# CITY OF ALBUQUERQUE

RE: **Lot 36 Block 6 Unit 18, S.A.D. 228**  
**Volcano Cliffs Subdivision**  
**6611 Sujeto Rd. NW**  
**Grading and Drainage Plan**  
**Engineers Stamp Date 7/9/2020 (D10D003M36)**

Based upon the information provided in your submittal received 7/15/2020, this plan is approved for Grading Permit.

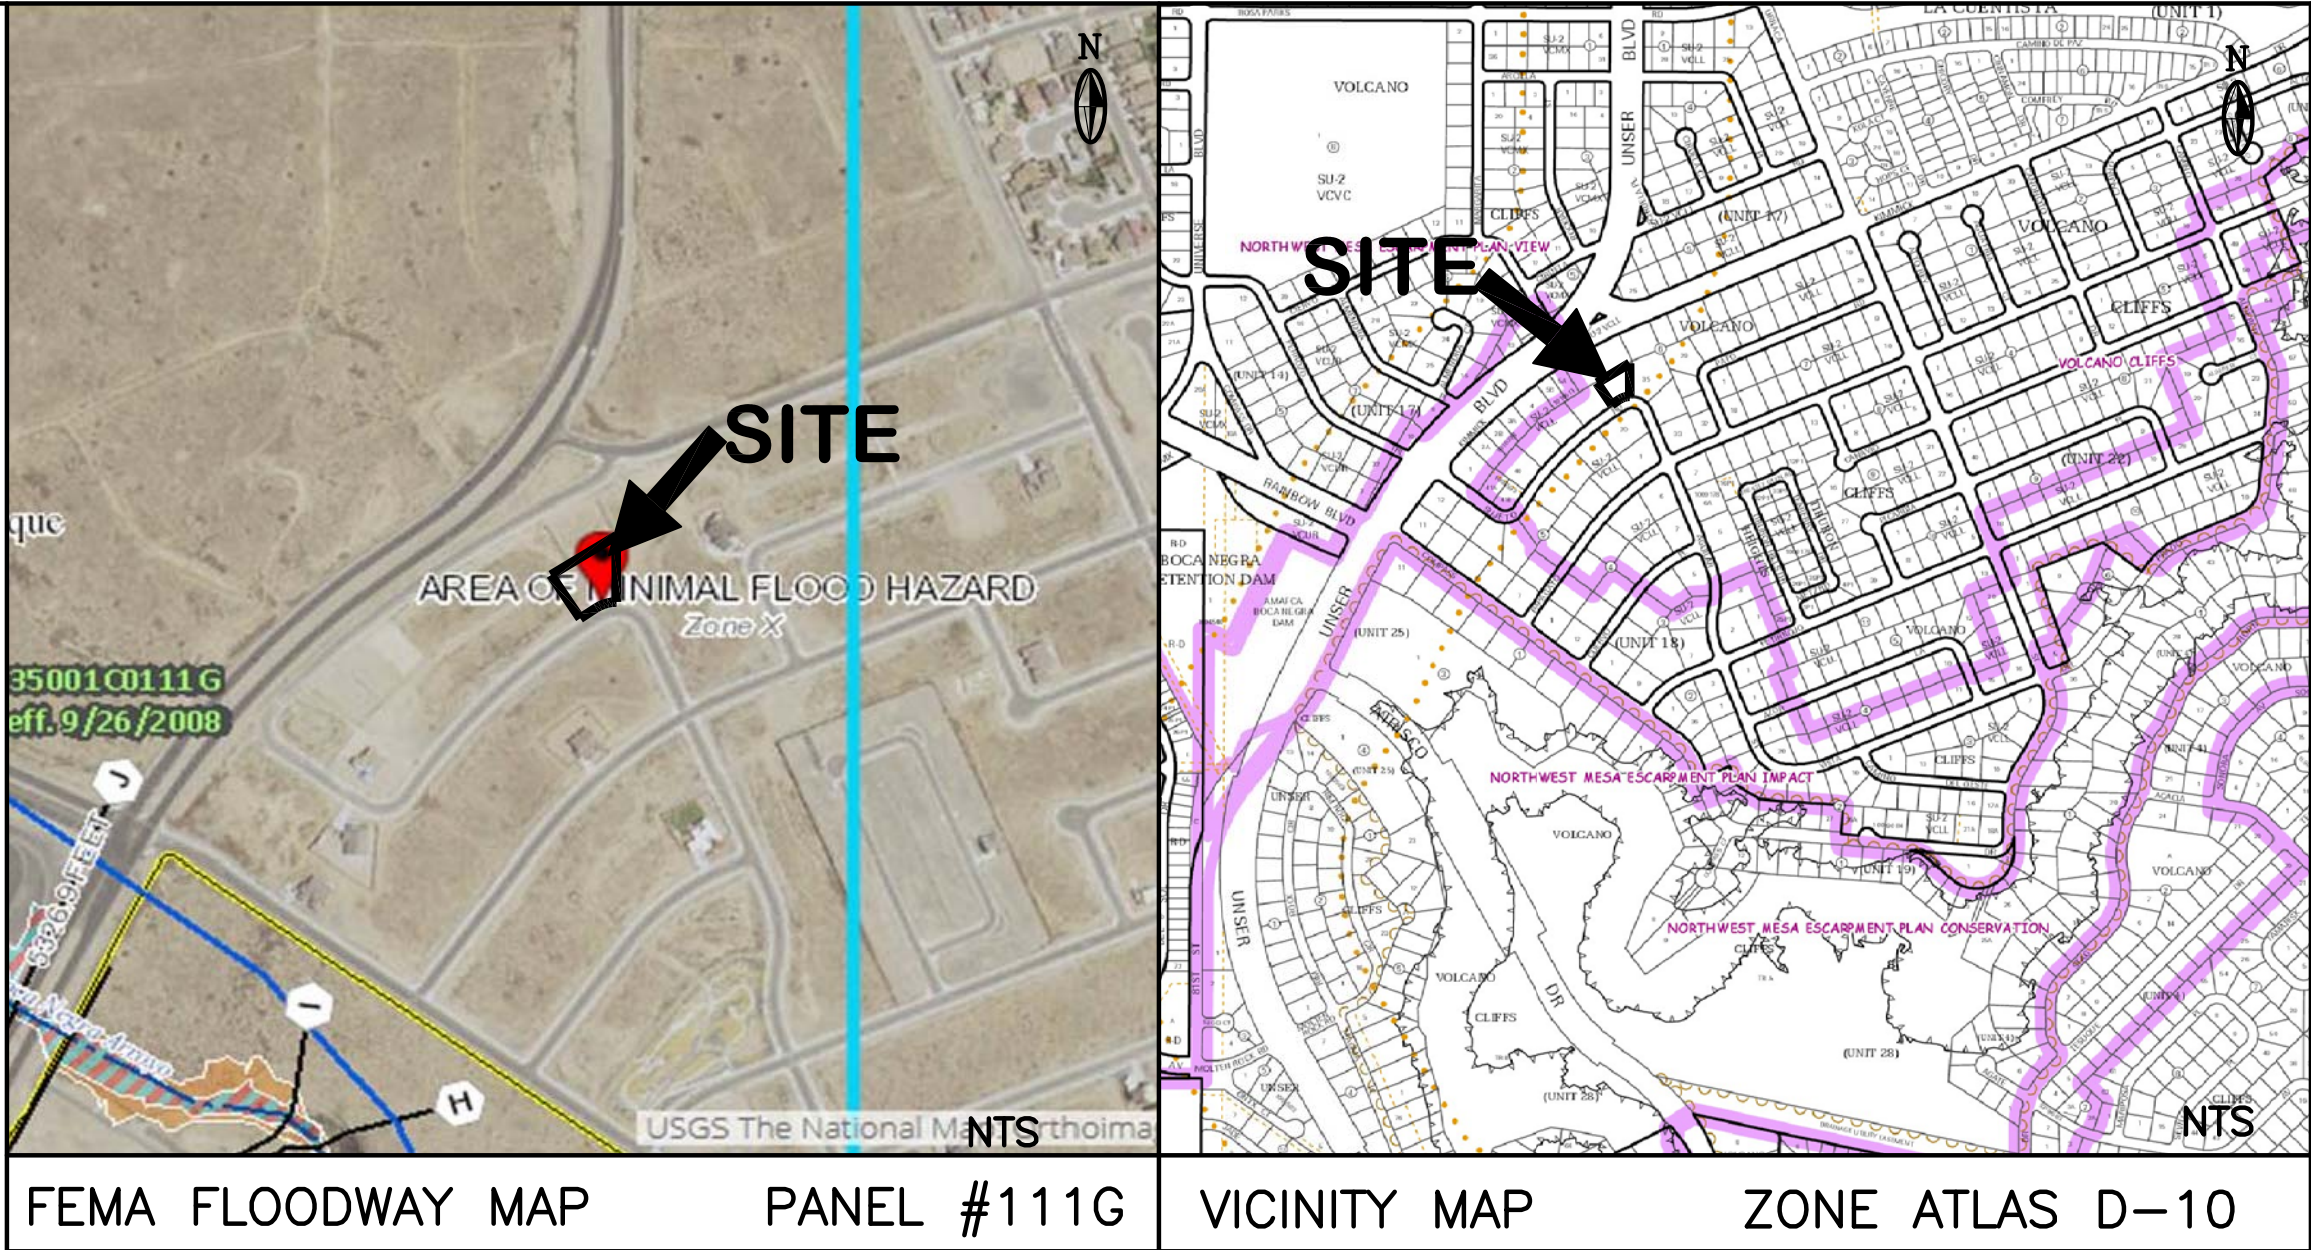
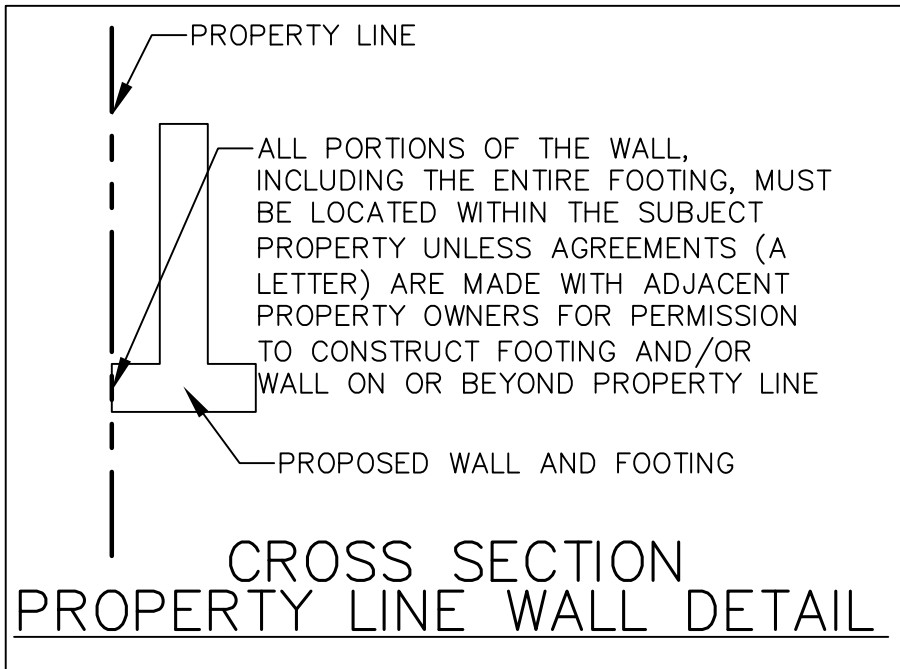
**Prior to Building permit approval a Pad Certification will be required, provided by the Engineer or a registered Land Surveyor.**

Reiterate to the Owner/Contractor that a separate permit for a garden/retaining wall must be obtained, with the approved G&D plan dated 7/10/2020.

Prior to Certificate of Occupancy release, Engineer Certification per the DPM checklist of this plan will be required.
